# Questionnaire 1 (Clarification) Exemption 13 of RoHS Annex IV

*Lead in counterweights of surgical C-arm X-ray and C-arm fluoroscopy designed to have radiologist present with patient*

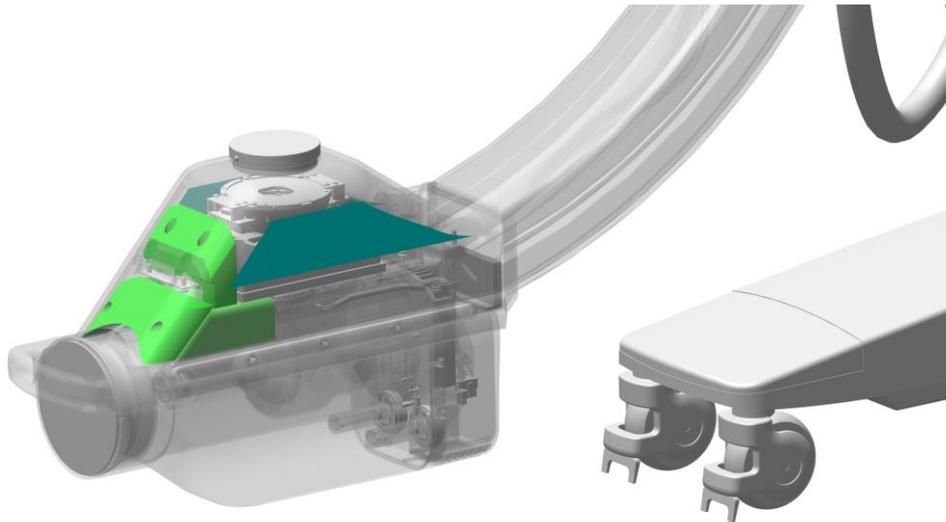
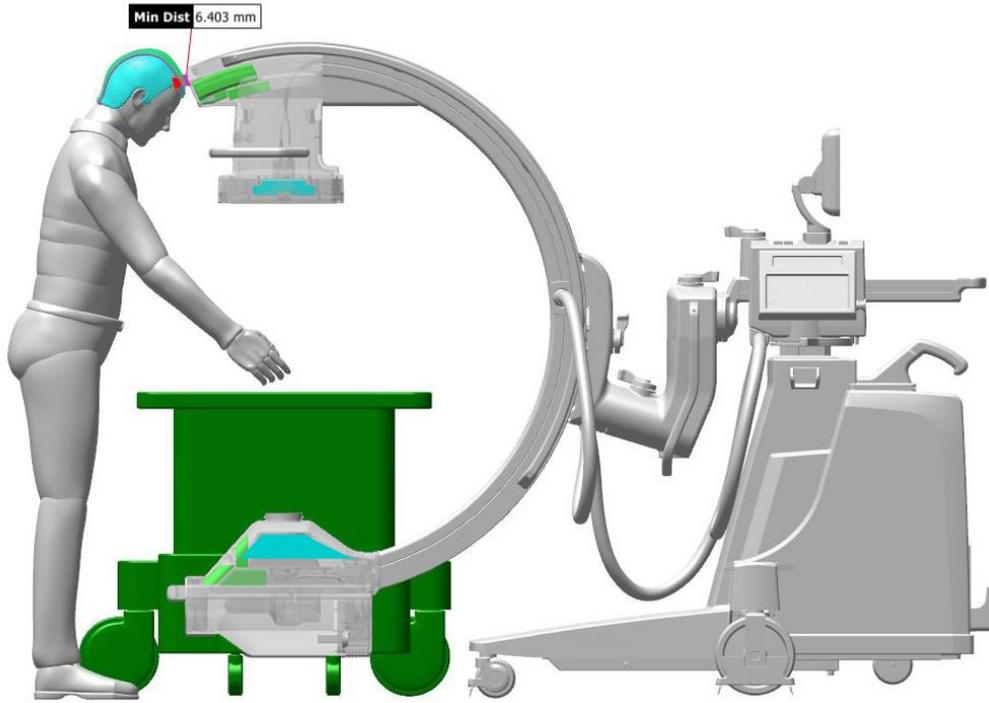
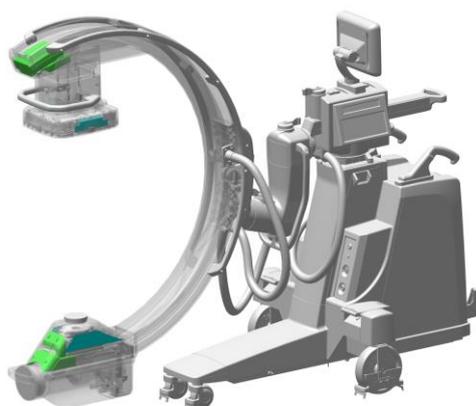
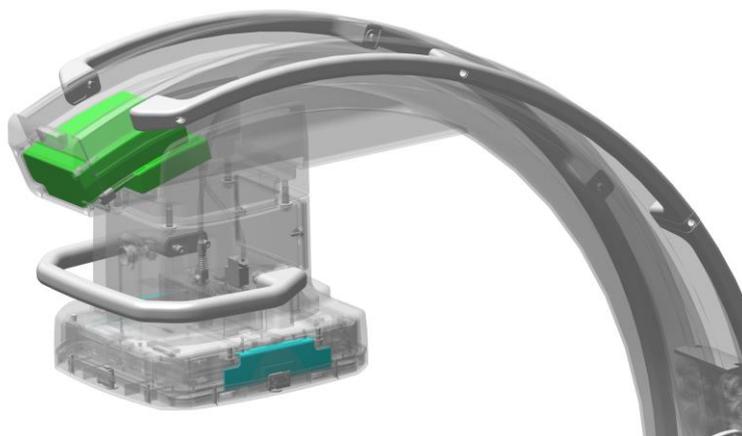
1. Could you please illustrate the location and the difference of the shielding and the counterweights in devices?

In the diagrams below, counterweights are shown as light green and shielding is blue.

The lead counterweights need to be sizable to counter balance the weight of the C-arm and cables inside the C-arm. Due to limited space near the x-ray tube and detector the shapes have been made to fit unique shapes to make use of all available space.

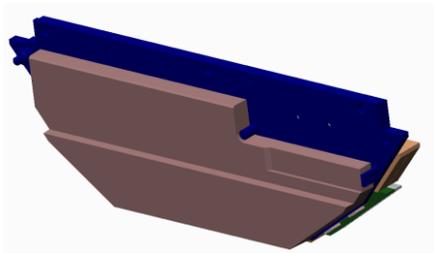
3. We are not quite sure about the technical feasibility of manufacturing counterweights from W.
  - a. You state that this is much more difficult than from lead. Does this mean it is possible, or so difficult that it is technically impracticable?

In fluoroscopy applications the tabletop can be moved by motor in longitudinal and lateral directions. The dynamic flat detector tilts with the table, and can be moved in three directions, relative to the table and to the patient. The table geometry moves from  $-85^{\circ}$  to  $90^{\circ}$ , which would be restricted if alternatives to lead were to be used which have a larger volume. The shielding has to ensure that all radiation is blocked so is in multiple places, both in the table and above, the counterweights are in the full length of table base, as well as at the end of the table.
